Dominion Nuclear Connecticut, Inc.
Millstone Power Station
Rope Ferry Road
Waterford, CT 06385

Docket No. 50-423
B18314

Millstone Nuclear Power Station, Unit No. 3
Technical Specifications Change Request 3-11-00
Reactor Coolant System Heatup and Cooldown Curves

FIGURE 3.4-4a

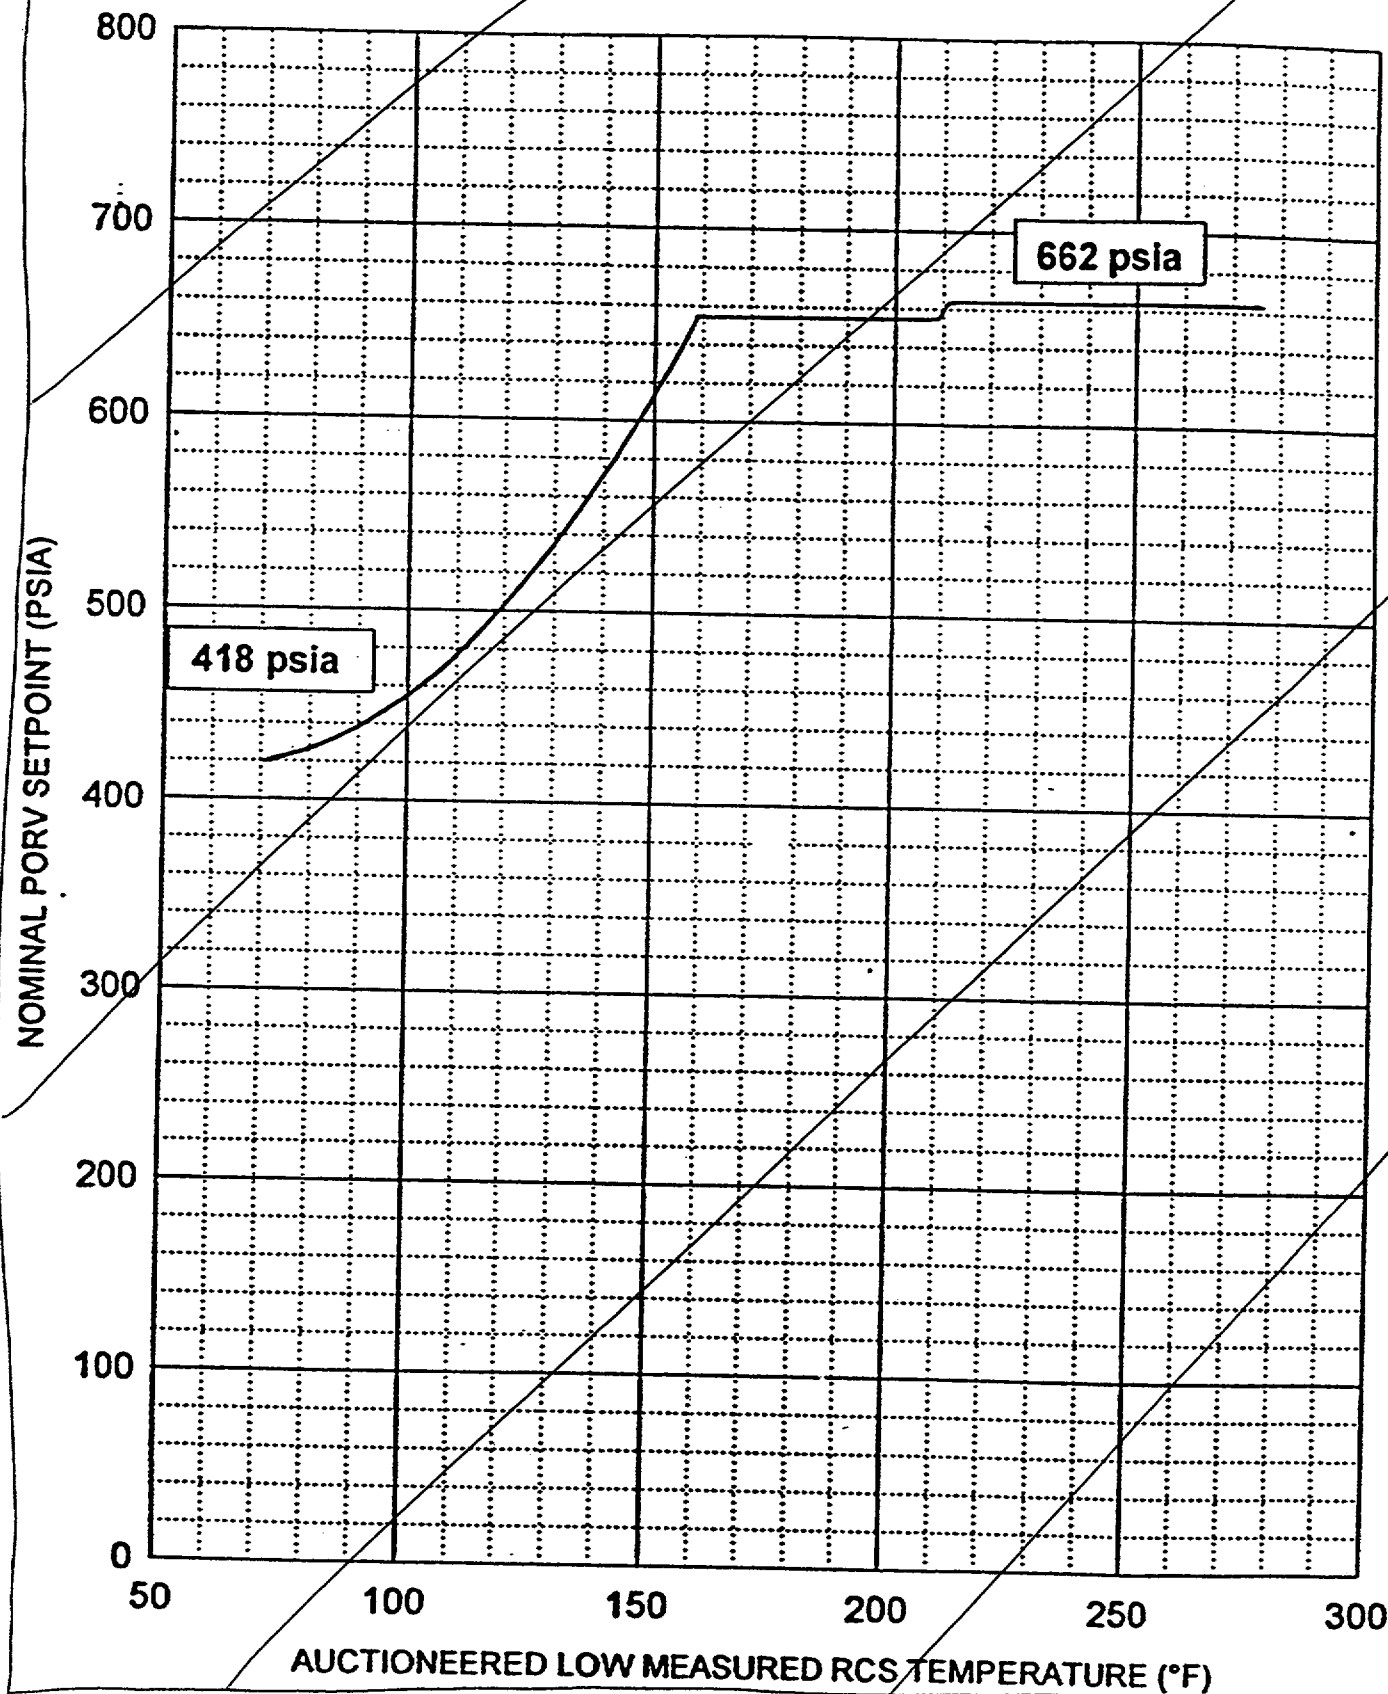
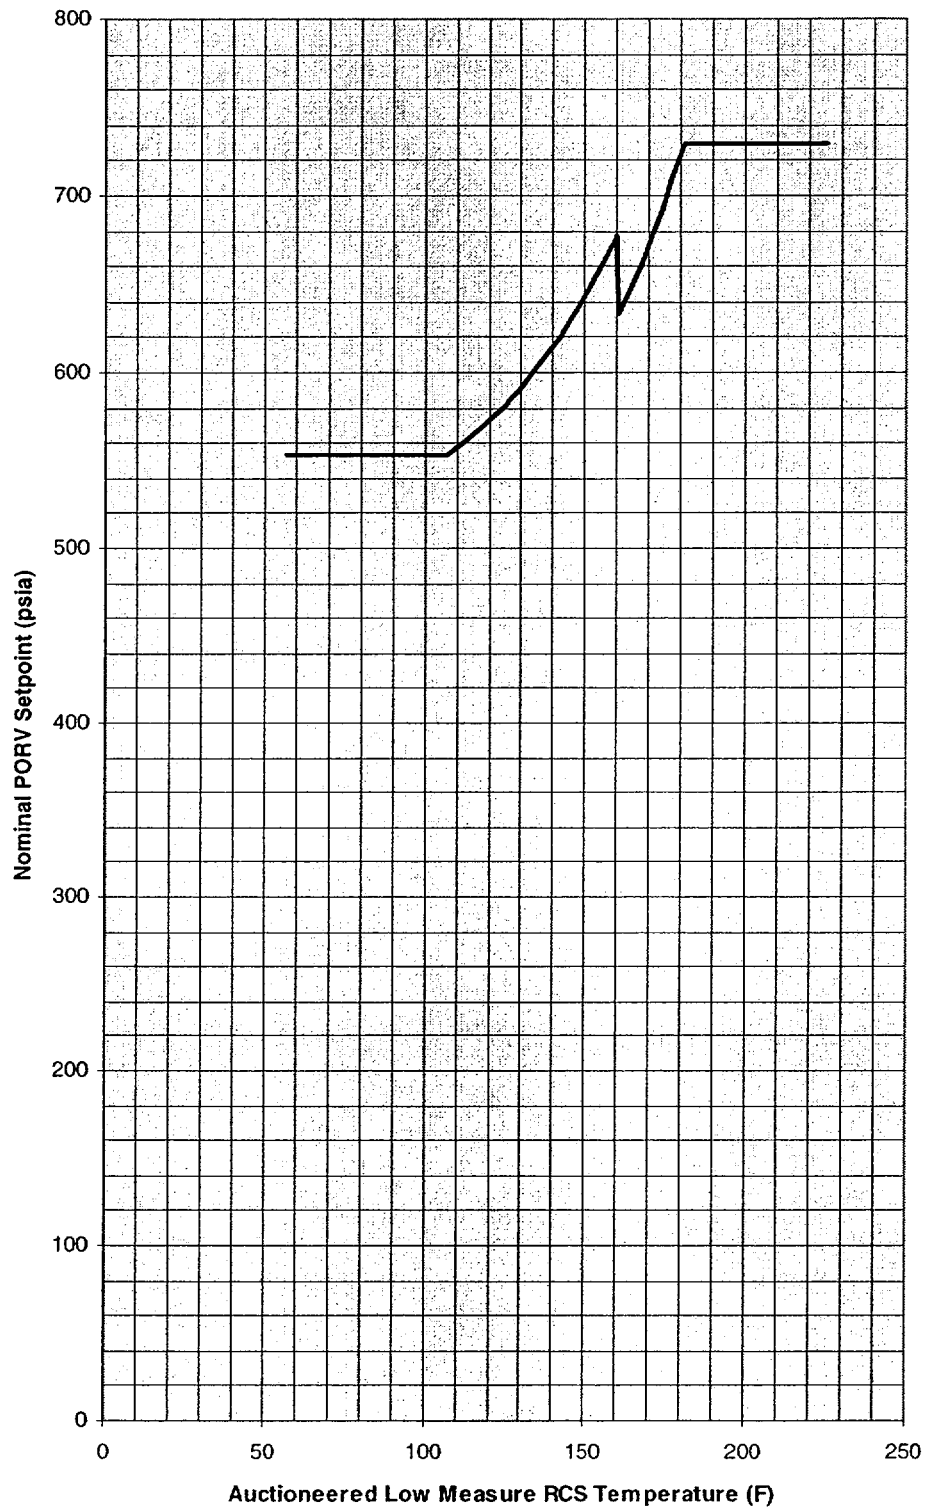
9. Figures 3.4-4a and 3.4-4b will be replaced by new curves based on the revised analysis.

**High Setpoint PORV Curve
for the Cold Overpressure System**
